ADDENDUM No. 1 TO PLANS AND CONTRACT DOCUMENTS

**EAST MARSH ISLAND MARSH CREATION
POST-CONSTRUCTION MAINTENACE EVENT**

CWPPRA NUMBER: TV-21

**ADDENDUM TO BID DOCUMENTS
EAST MARSH ISLAND MARSH CREATION
POST-CONSTRUCTION MAINTENANCE EVENT
IN IBERIA PARISH, LOUISIANA
CWPPRA NUMBER: TV-21**

DRAWN BY: WAC DESIGNED BY: WAC

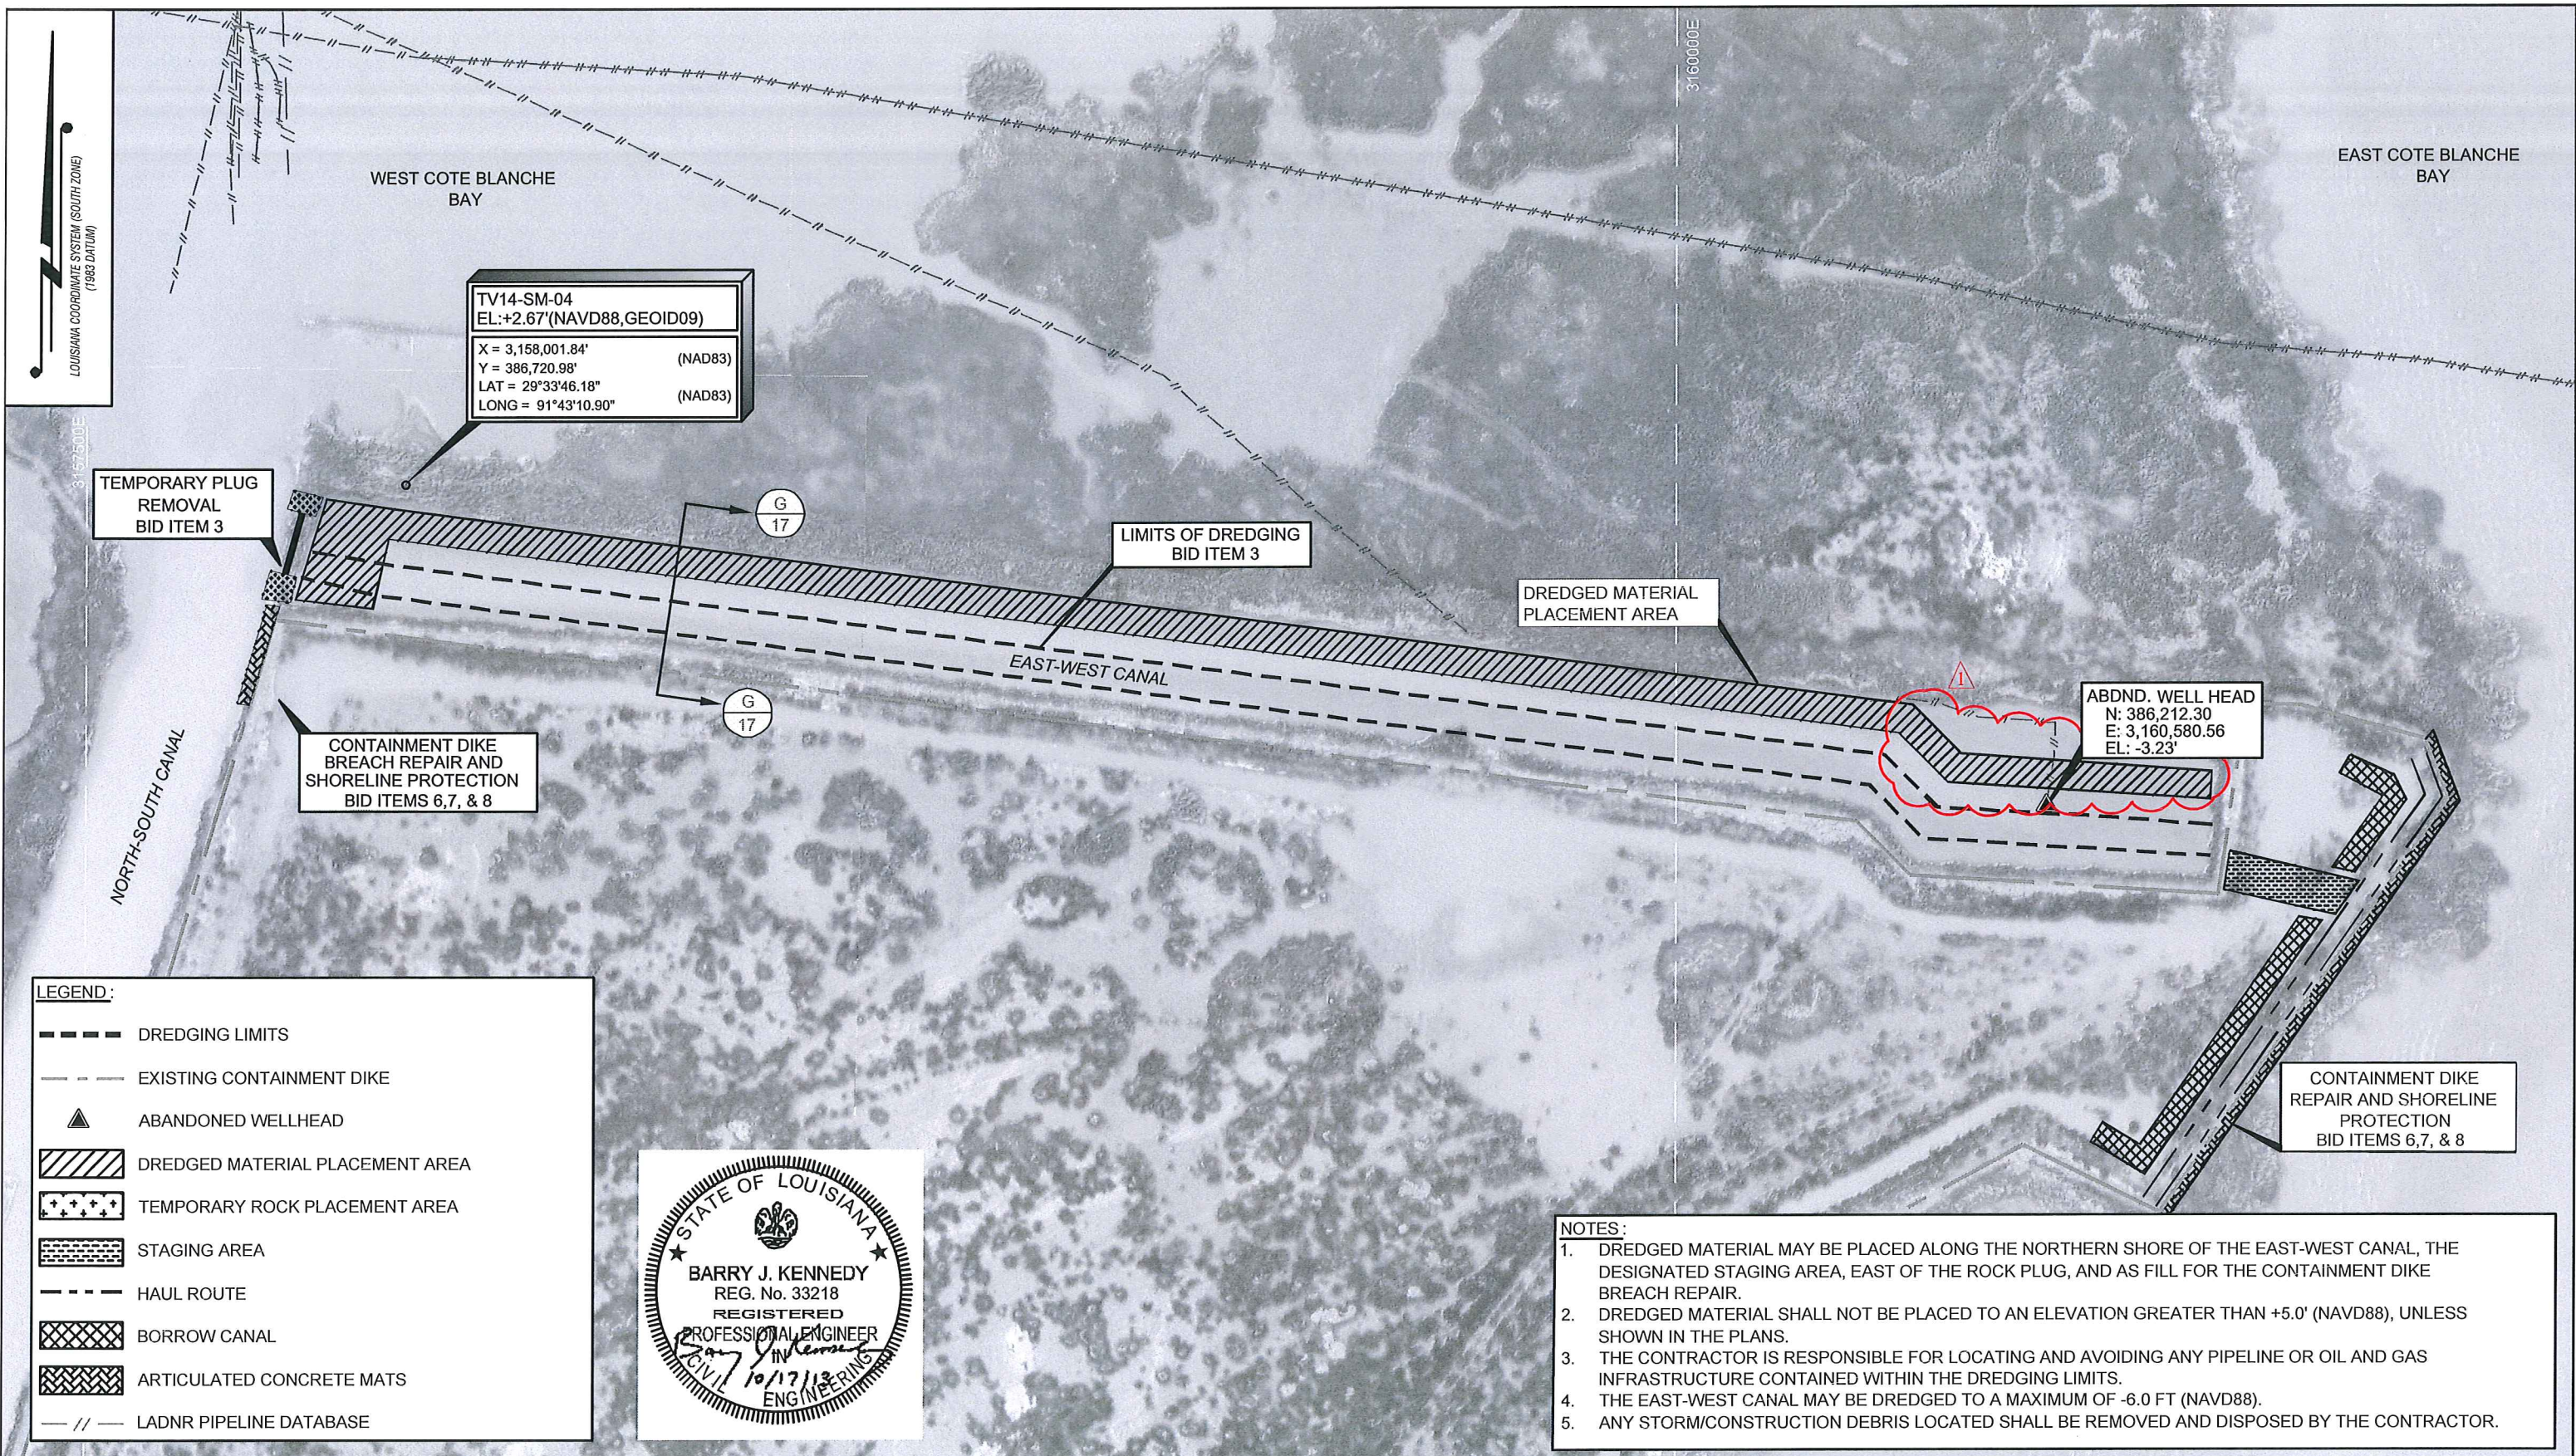
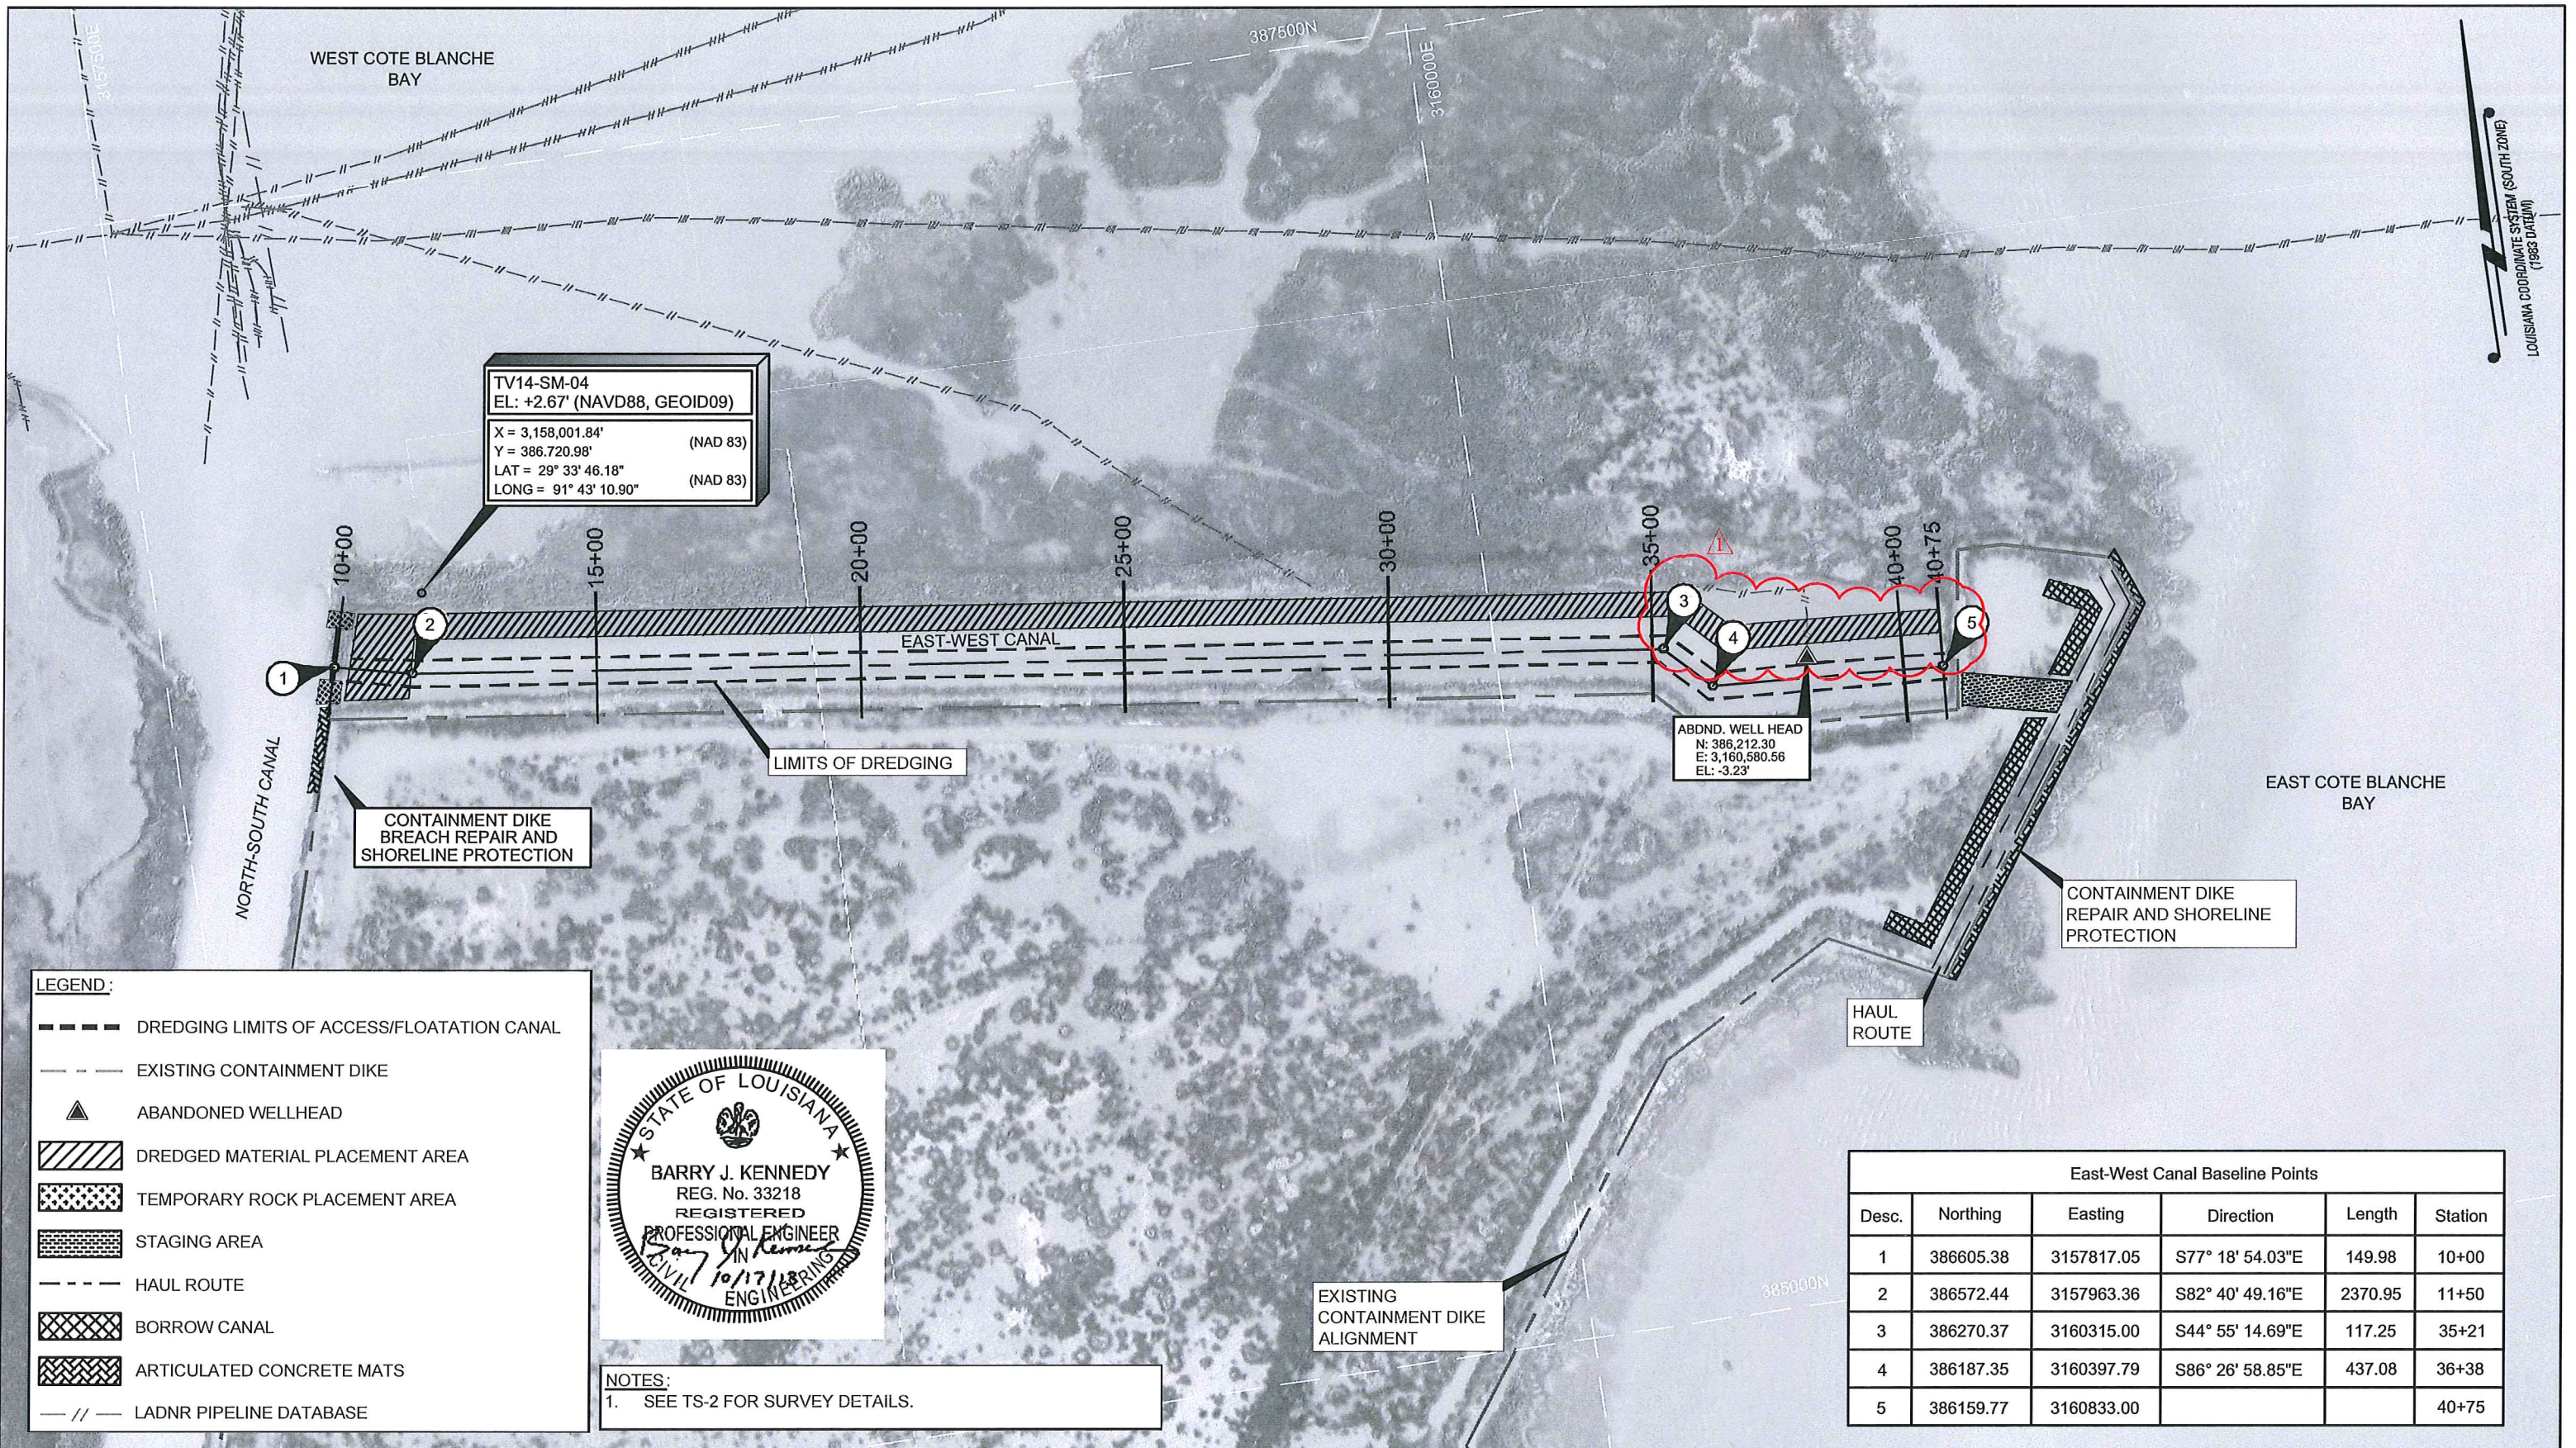
- 1.4.** Material dredged from the East-West Canal may be “Side-Cast” the entire length of the canal. See Plan Sheets 4 through 7 in Attachment A of this Addendum.

- 1.7.** An inconsistency in dredging limits was brought to attention. These inconsistencies have been addressed and shown on the revised Plan sheets presented in Attachment A of this Addendum.

| COASTAL PROTECTION AND RESTORATION AUTHORITY 450 LAUREL ST. STE. 1501 BATON ROUGE, LOUISIANA 70801 | | EAST MARSH ISLAND MARSH CREATION POST-CONSTRUCTION MAINTENANCE EVENT | TEMPORARY ROCK PLUG REMOVAL AND BREACH REPAIR LAYOUT |

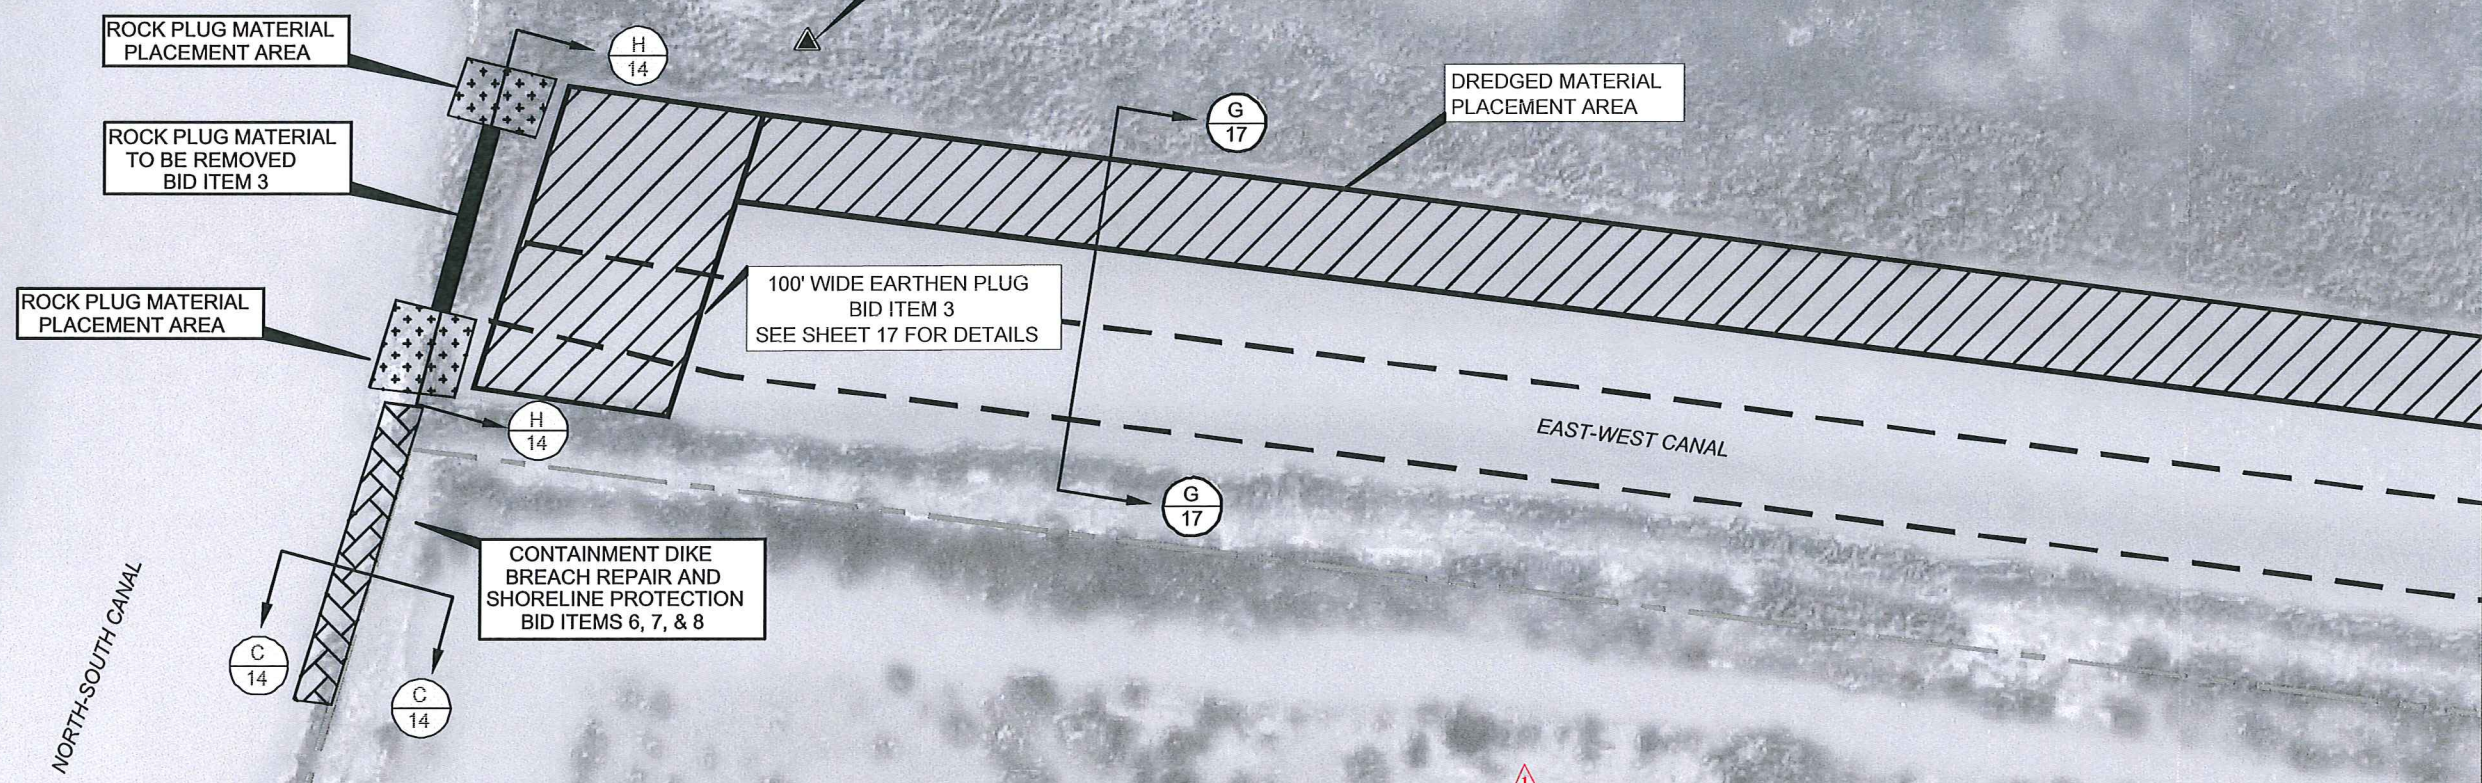
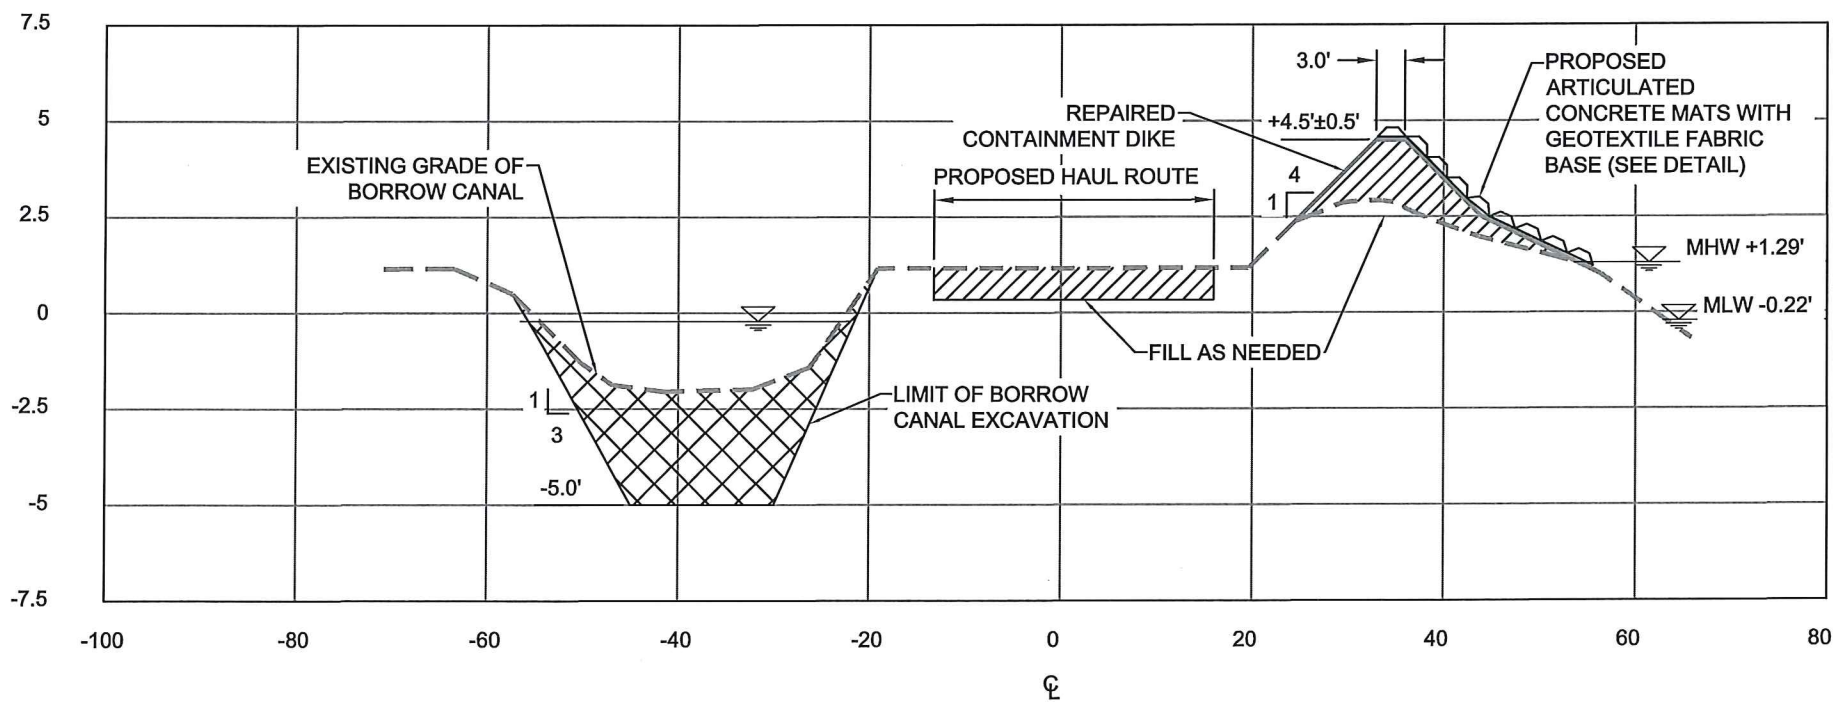
- 1.2.** The Plans and Specifications will be updated to clarify the material replacement of the rock plug shall be **within** the pre-construction lines, grades, and elevations.

- 1.6.** A question regarding Note 5 on Plan Sheet 8 was discussed. Dredging of the North-South Canal shall be strictly limited to wheel-washing or minor dredging to allow direct access to the Rock Plug. This dredging is permitted, with approval from the ENGINEER, if found compliant with the consistency permit issued for original construction of the project. The material dredged from the North-South Canal shall not be used as a fill or a borrow source.

- THE ROCK PLUG IS TO BE RECONSTRUCTED WITHIN THE LINES, GRADES, AND ELEVATIONS OF THE PRE-CONSTRUCTION SURVEY PRIOR TO DEMOBILIZATION, DREDGED MATERIAL FROM THE EAST-WEST CANAL MAY BE USED.
- EXCAVATED ROCK PLUG MATERIAL IS TO BE PLACED AREAS ADJACENT TO THE EXCAVATION AS SHOWN ON THE PLANS.
- DREDGED MATERIAL FROM THE EAST-WEST CANAL SHALL BE PLACED TO FORM A 100.0' EARTHEN PLUG AT +1.5' ELEVATION EAST OF THE ROCK PLUG PRIOR TO DEMOBILIZATION, PAID THROUGH BID ITEM 3.
- EXCAVATED MATERIAL SHALL NOT BE PLACED AS TO IMPEDE NAVIGATION OF EXISTING WATERWAYS.
- THE NORTH-SOUTH CANAL MAY BE DREDGED, WITH APPROVAL BY THE ENGINEER, TO ACCESS THE ROCK PLUG AND EAST-WEST CANAL.
- THE CONTRACTOR IS TO COLLECT AND DISPOSE ANY STORM OR CONSTRUCTION DEBRIS FOUND NEAR THE WORK AREA.
